ADDENDUM NUMBER FOUR

**DISTRICT FIVE OF
LEXINGTON & RICHLAND COUNTIES
CHAPIN ELEMENTARY SCHOOL**

**CALLOWAY JOHNSON MOORE WEST (CJMW)
201 WEST MAIN STREET
LEXINGTON, SOUTH CAROLINA 29072**

DATE OF ISSUE: April 9, 2009

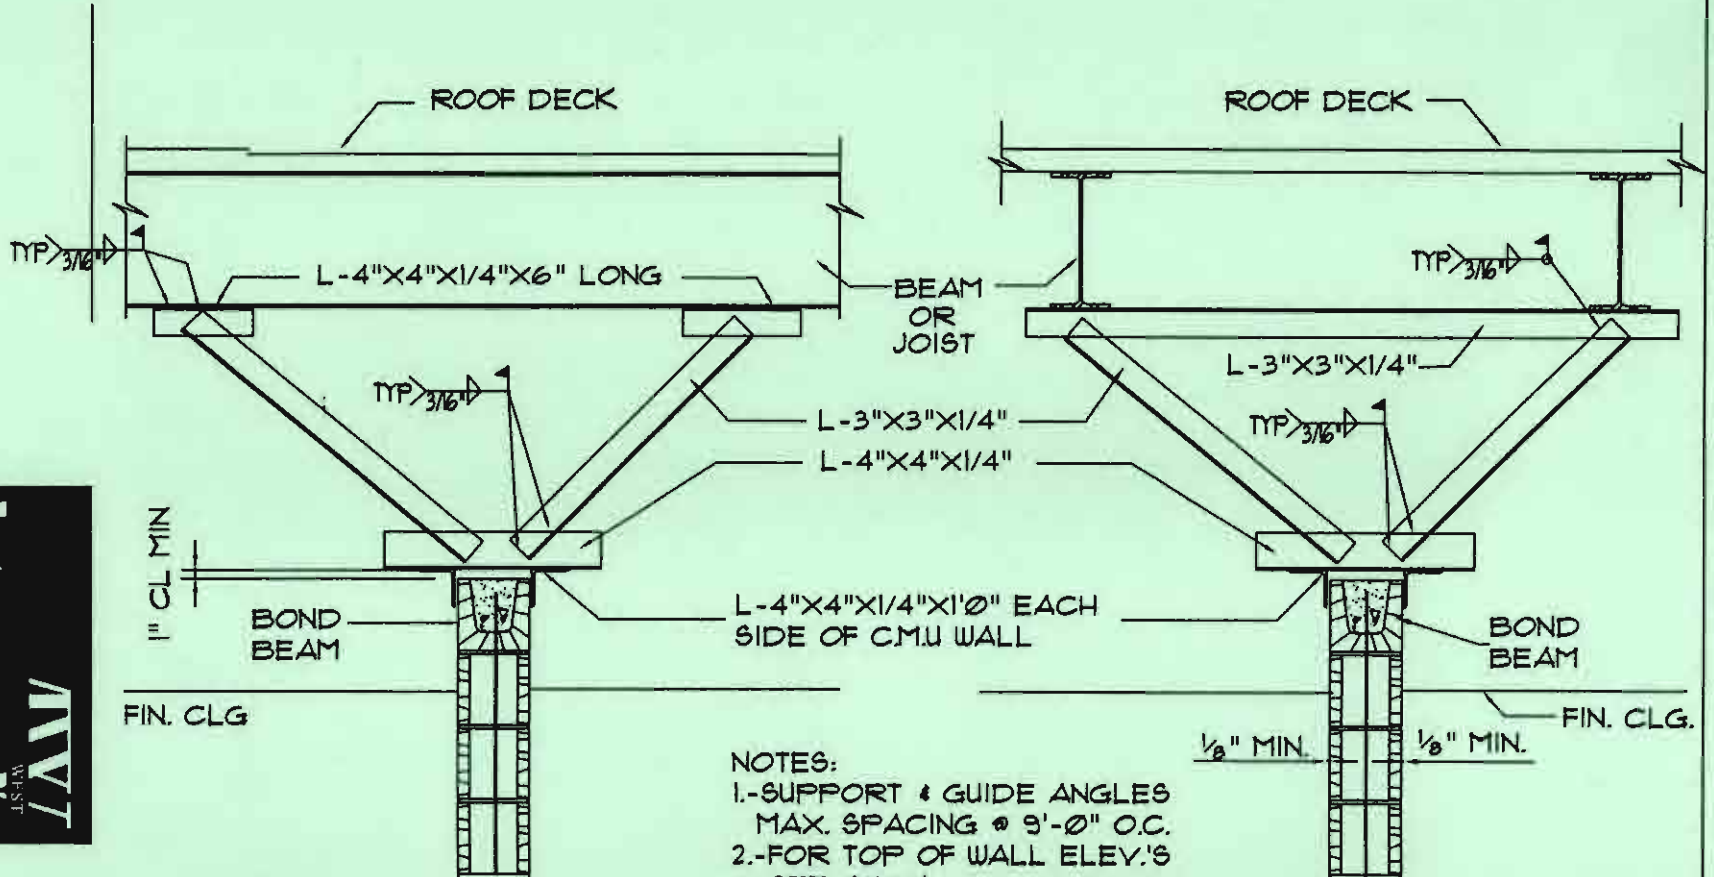
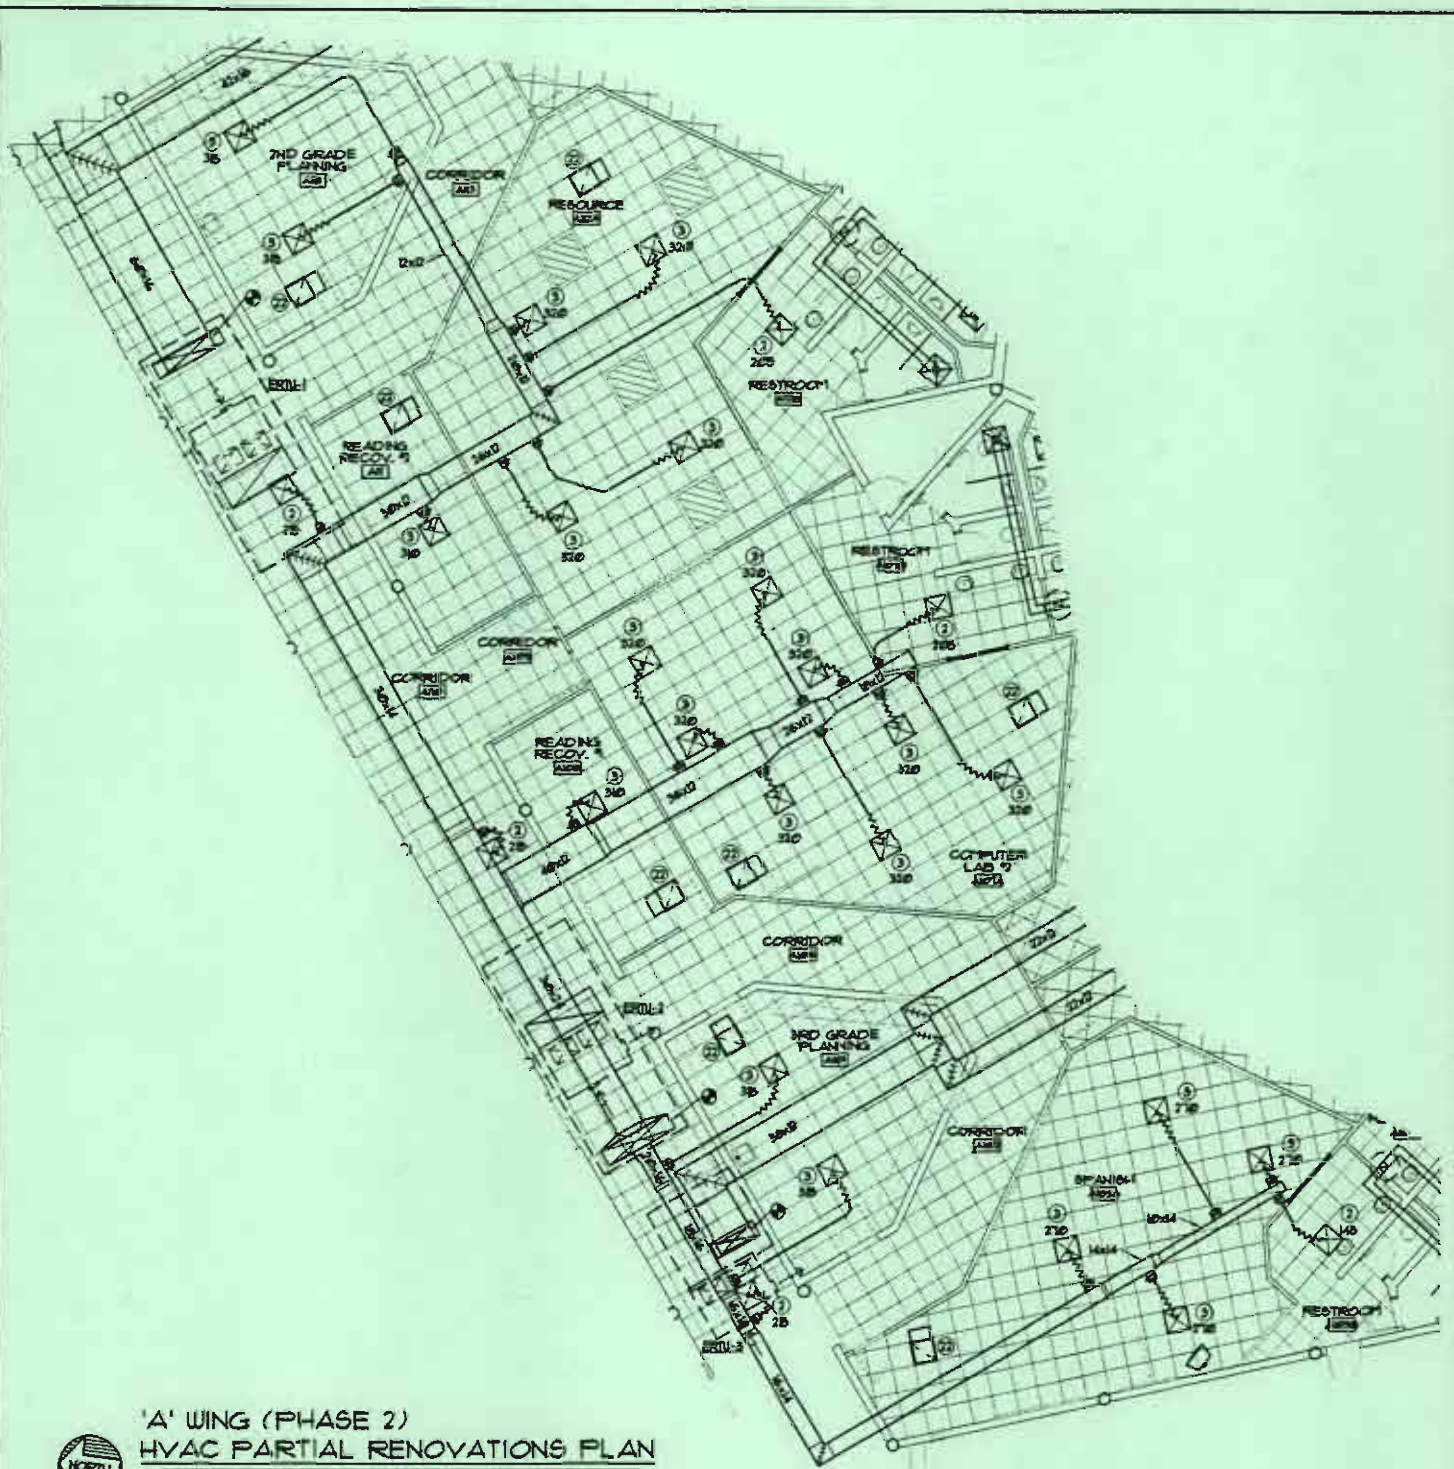
32. **Drawing Sheet S401:**
See the Skylight Framing Detail on **attached Sketch BDS002.**
33. **Drawing Sheet S401:**
See the Skylight Non Bearing CMU Wall Bracing Detail on **attached Sketch BDS003.**
34. **Drawing Sheet SP2:**
Refer to Arch drg, sht A201 for skylights being added in rooms A112A, B114A and B125A. Contractor shall provide horiz sidewall head for coverage at skylights as required. Piping to sidewall head shall rise concealed in stud furring with reducing 90 at top of rise. Coordinate with general contractor as required. (See skylight details sht A601)
35. **Drawing Sheet P3:**
Coordinate routing of 2" vent piping to Toilet A129 to prevent conflicts with exist gyp board ceilings. (Refer to Arch drgs, sht A208 as required)
36. **Drawing Sheet P7:**
Refer to Civil drgs, sht C4 and provide connection to 6" sanitary stub approx where indicated.

- NOTES:
1. PROVIDE WALL BRACING AS SHOWN IN STRAIGHT RUNS OF WALLS LONGER THAN 9'-0" WHICH DO NOT HAVE INTERSECTING WALLS. LOCATE BRACING AS REQUIRED TO LIMIT THE MAXIMUM WALL LENGTH WITHOUT BRACING OR INTERSECTING WALLS TO 9'-0". ALSO PROVIDE BRACING WHERE SPECIFICALLY NOTED ON ROOF FRAMING PLANS.
 2. SEE THE ARCHITECTURAL DRAWINGS FOR TOP OF WALL ELEVATIONS.

'A' WING - HVAC PARTIAL RENOVATIONS PLAN

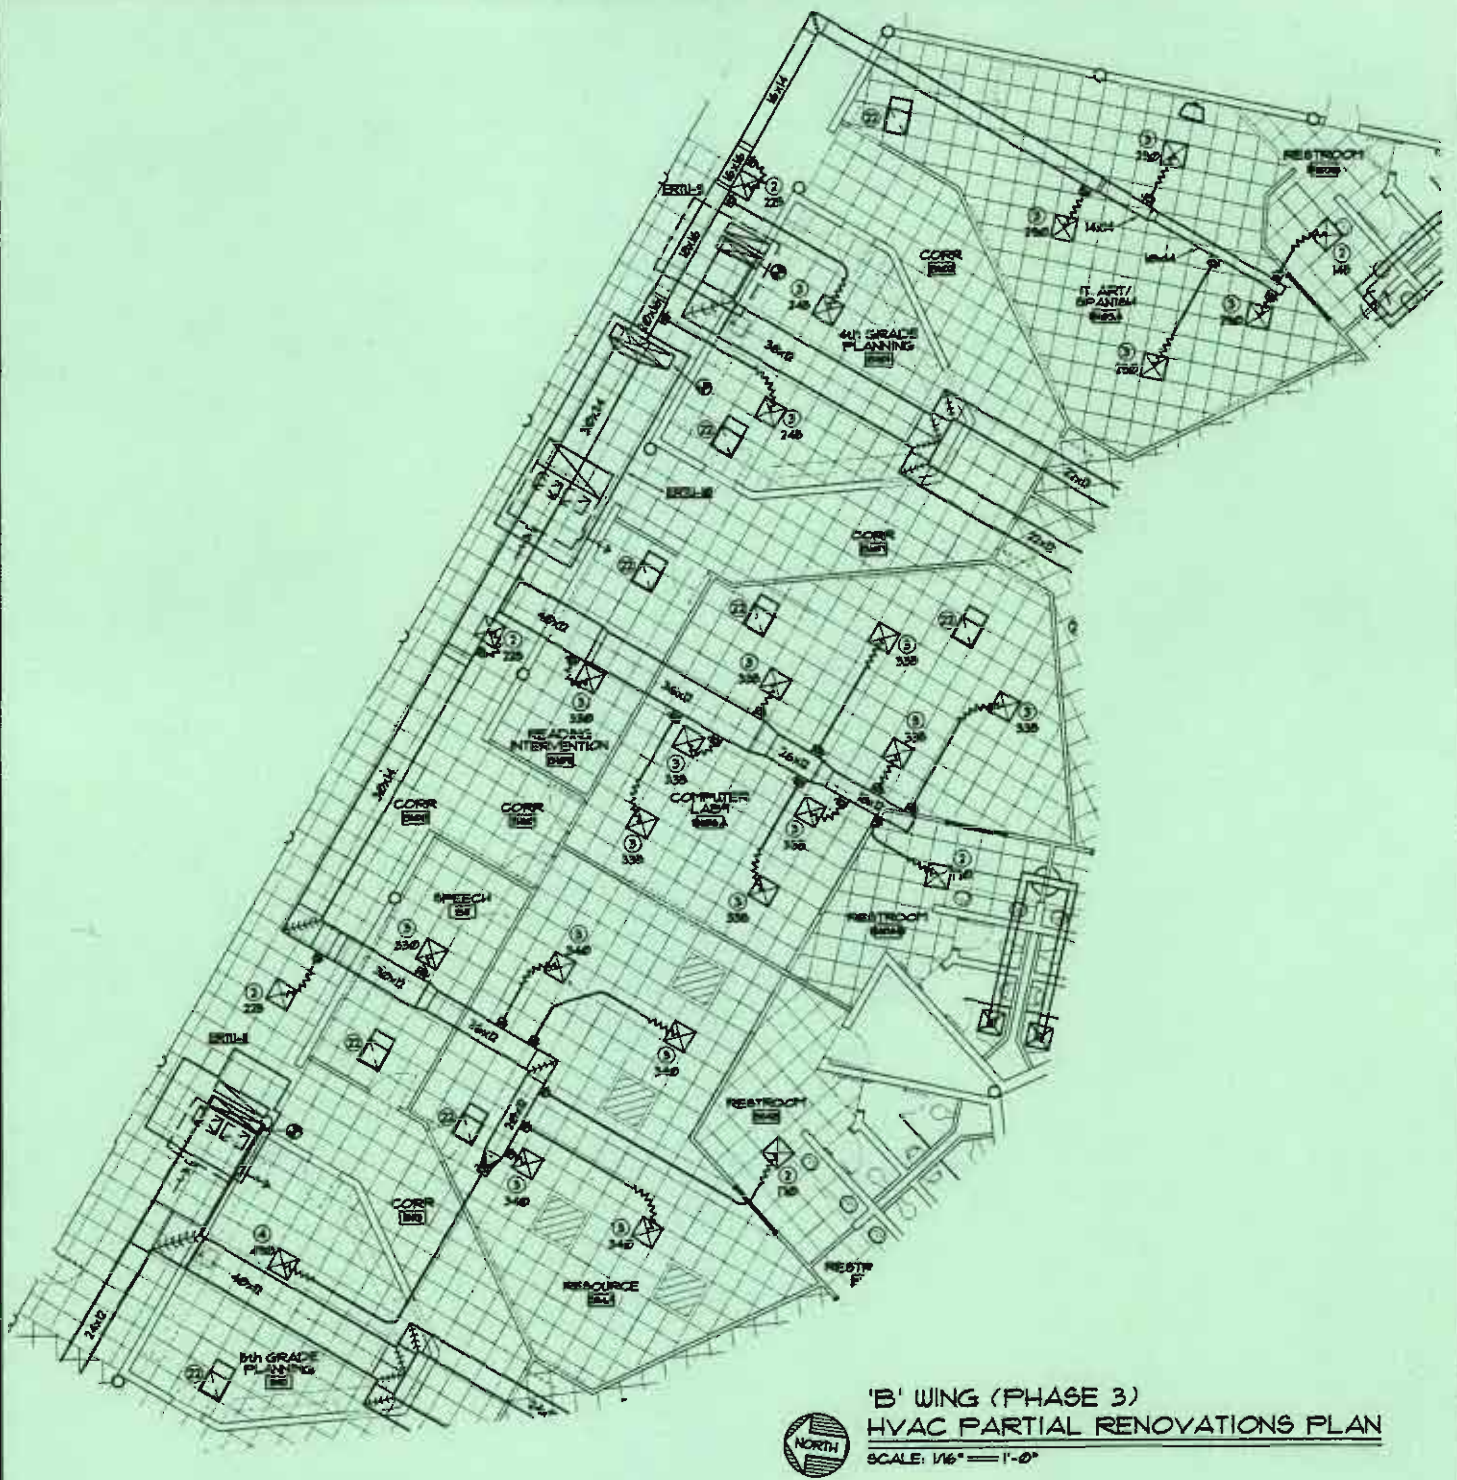
40. **Drawing Sheet M5:**
(See attached sketch **BDM001**) for revisions to duct sizes, diffusers sizes, and grille/diffuser air flows associated with rooftop unit ERTU-2.

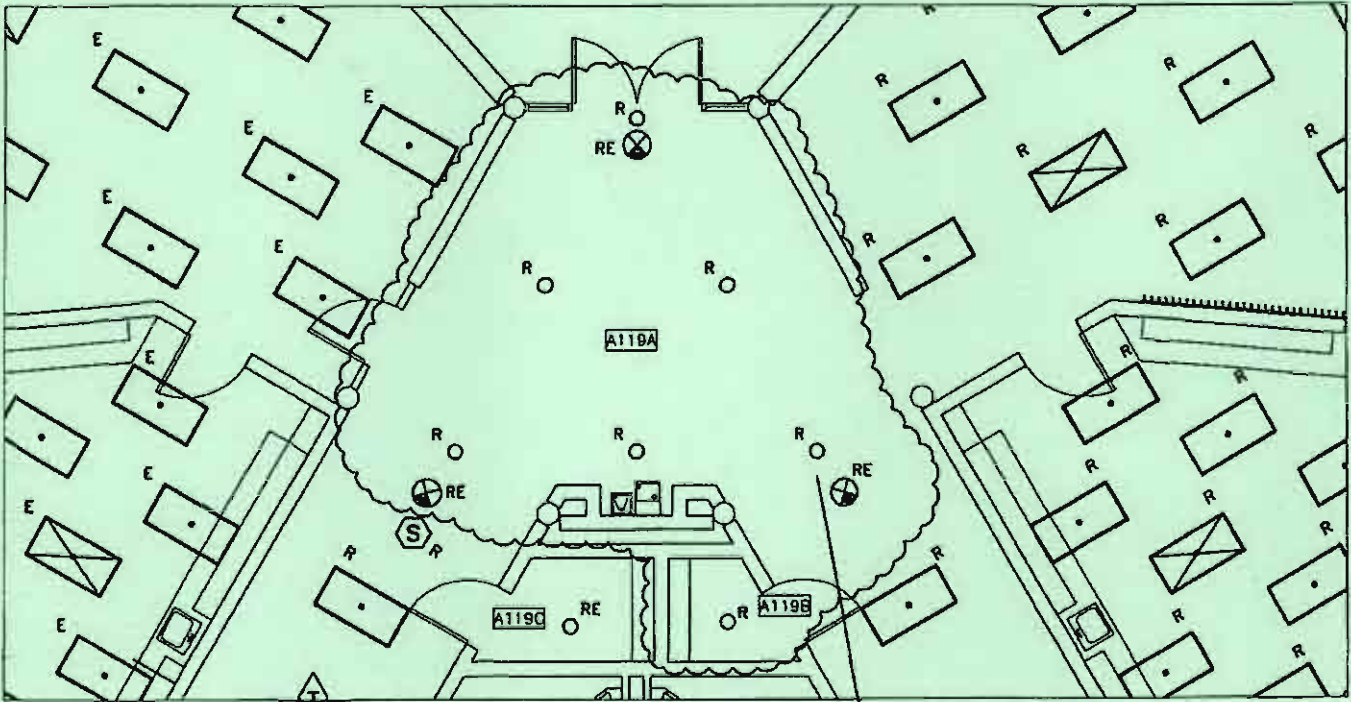
43. **Drawing Sheet M11:**
 (See attached sketch BDM004) for the GRILLE AND DIFFUSER SCHEDULE.

BDE001

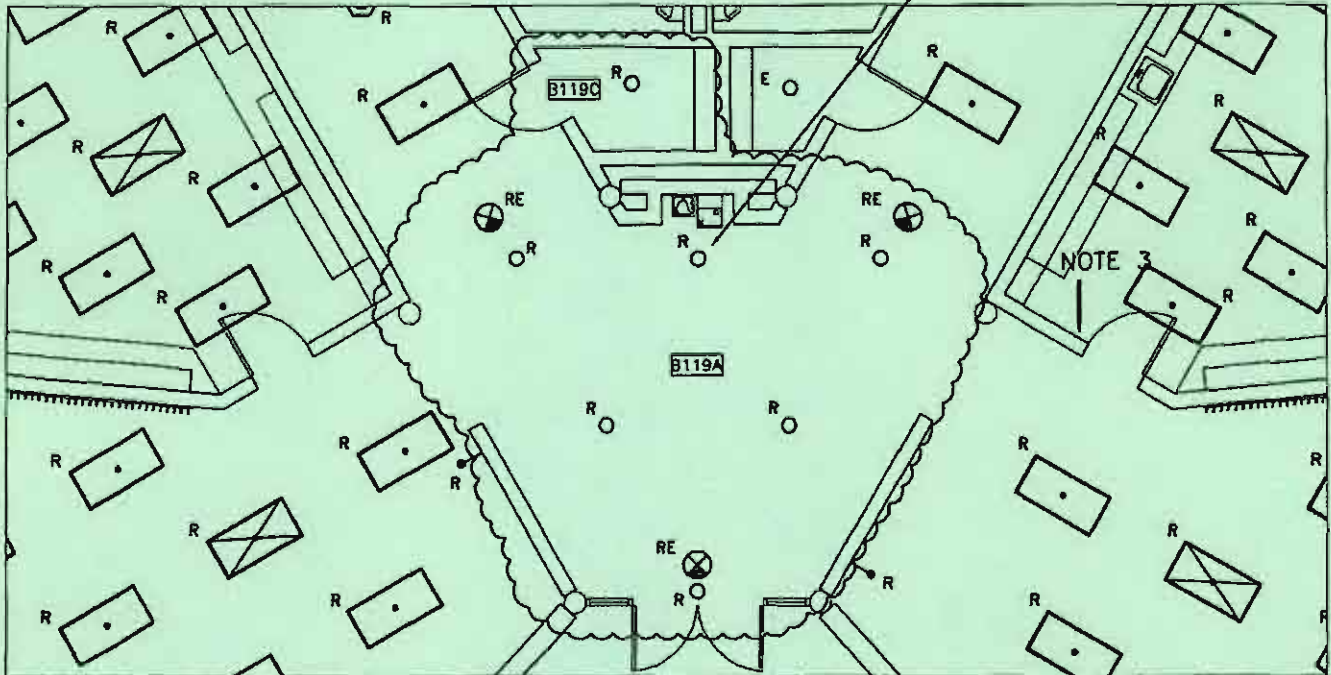
46. **Drawing Sheet E1.0:**
 1. (See sketch BDE001).

Reference Sheet E1.1

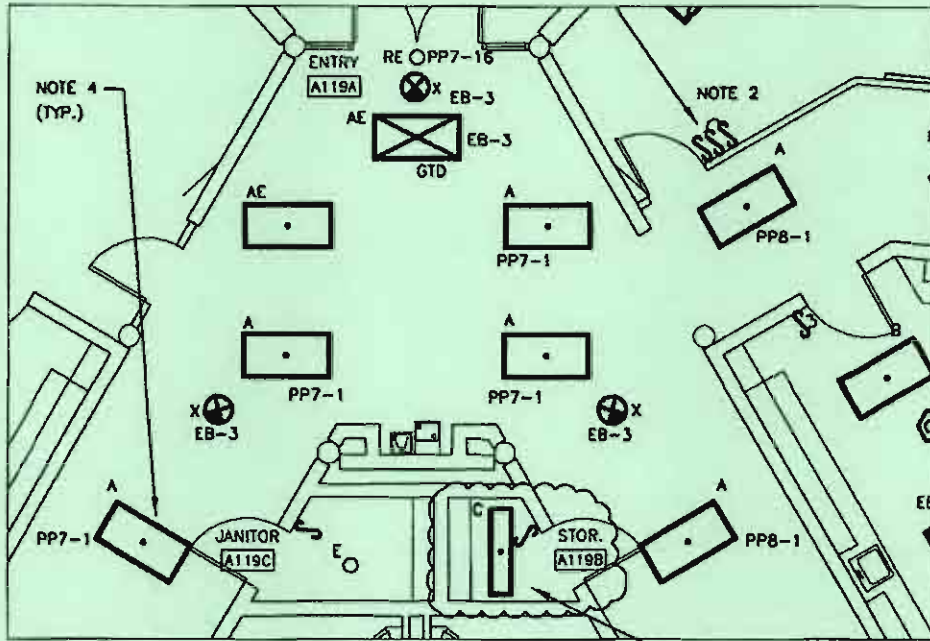
47. **Drawing Sheet E1.1:**
 1. (See sketch BDE002).

PROVIDE NEW TYPE "C" FIXTURE CHAIN HUNG FROM STRUCTURE.
 CONNECT FIXTURE TO EXISTING LIGHTING CIRCUIT IN THIS ROOM.

Reference Sheet E2.0

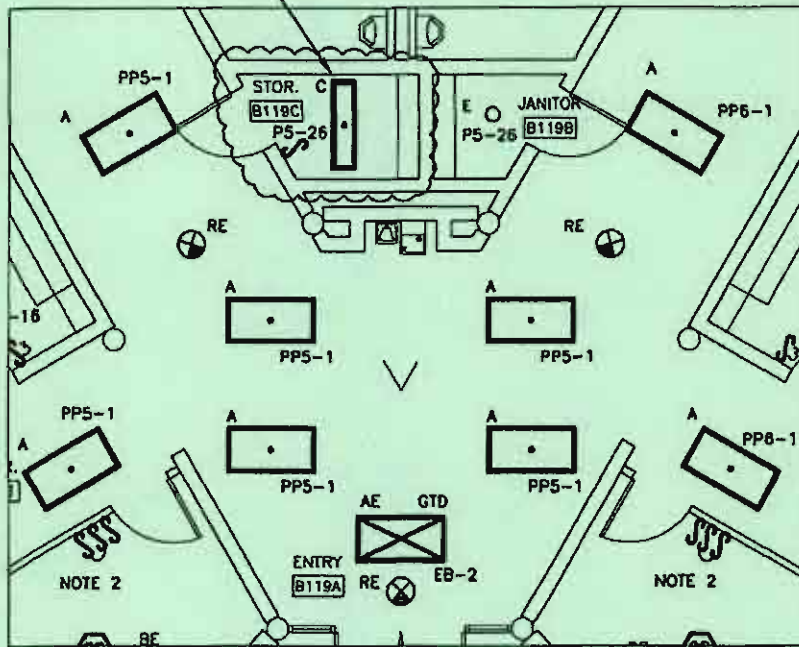
50. **Drawing Sheet E2.0:**
 1. (See sketch BDE003).

PROVIDE NEW TYPE "C" FIXTURE CHAIN HUNG FROM STRUCTURE.

BDE004

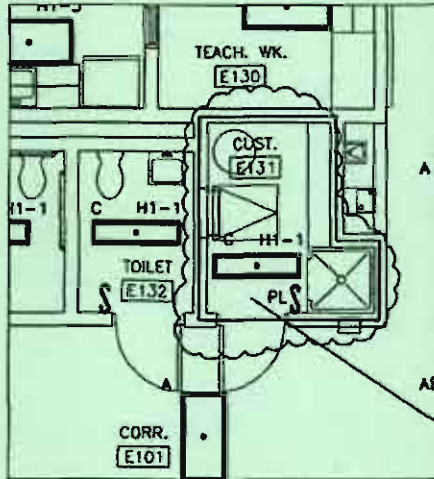
51. **Drawing Sheet E2.1:**
 1. (See sketch BDE004).
 2. (See sketch BDE008).

TYPE "C" FIXTURE SHALL BE CHAIN HUNG FROM STRUCTURE.

Reference Sheet E2.4

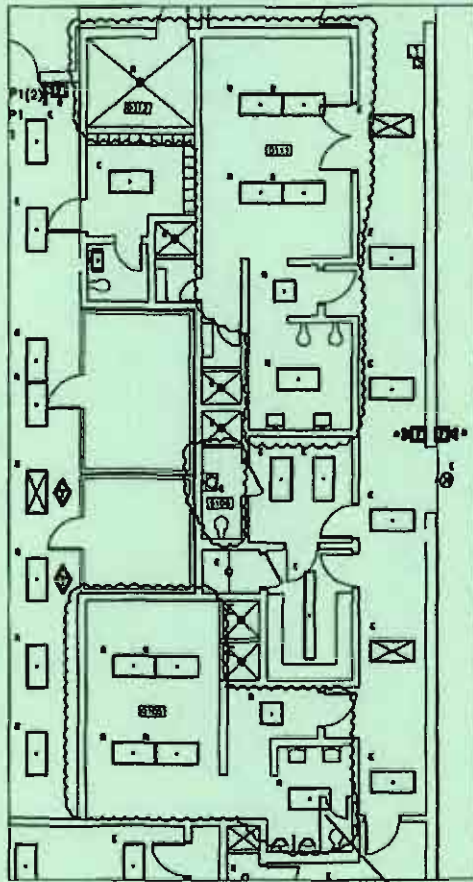
53. **Drawing Sheet E2.4:**
 1. (See sketch BDE005).

BDE006

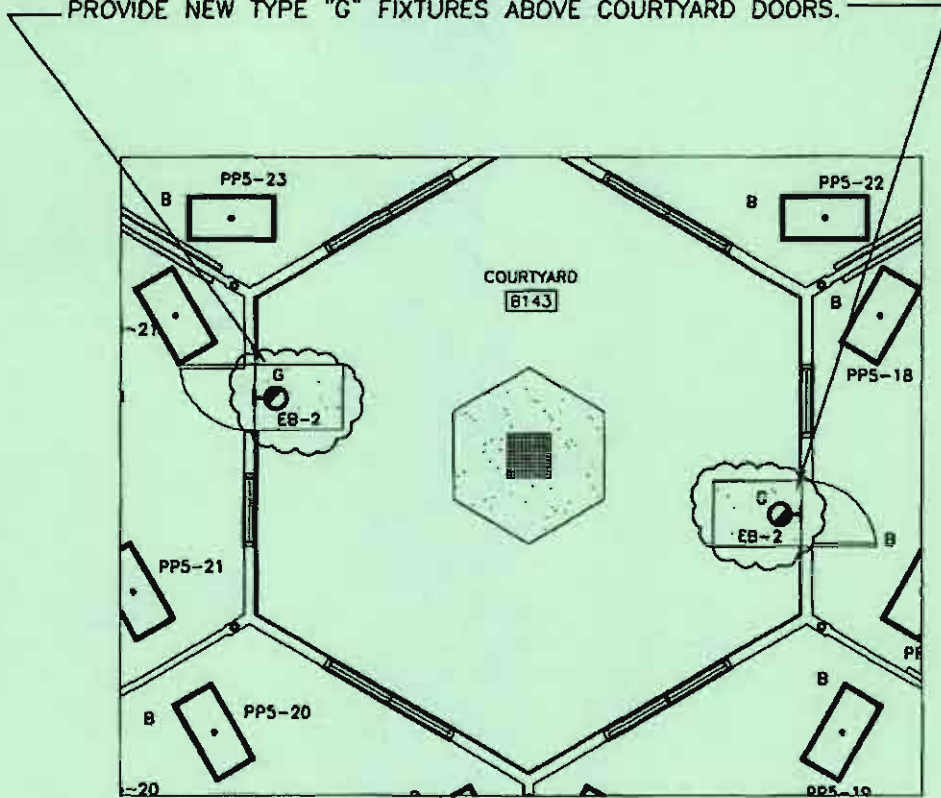
49. **Drawing Sheet E1.3:**
 1. (See sketch BDE006).

PROVIDE NEW TYPE "G" FIXTURES ABOVE COURTYARD DOORS.
